STANDARDS SHEET

DRAWN	M. ROSSO	CLASSIFICATION	STANDARD
CHECKED	KROMKAMP	BOLT	CSP 397
STRESSED	M. Russo		
APPROVED	S. S. HENNING

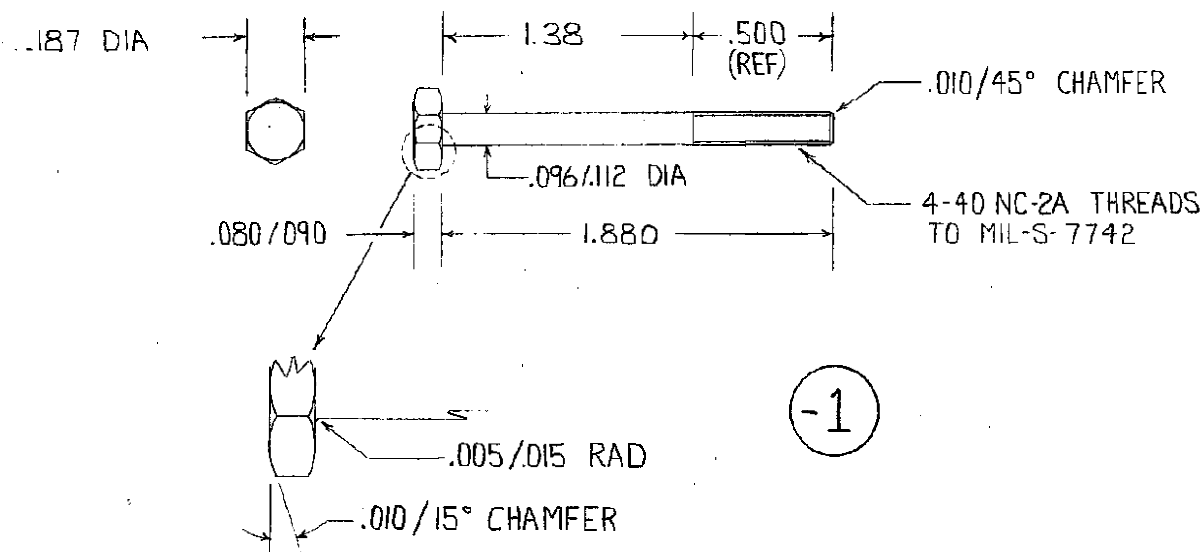
CHANGED THREAD LENGTH FROM 1.38
CHANGED HEX DIA FROM .312. ADDED
.187 TO MATERIAL NOTE M.R. 30 APR 84
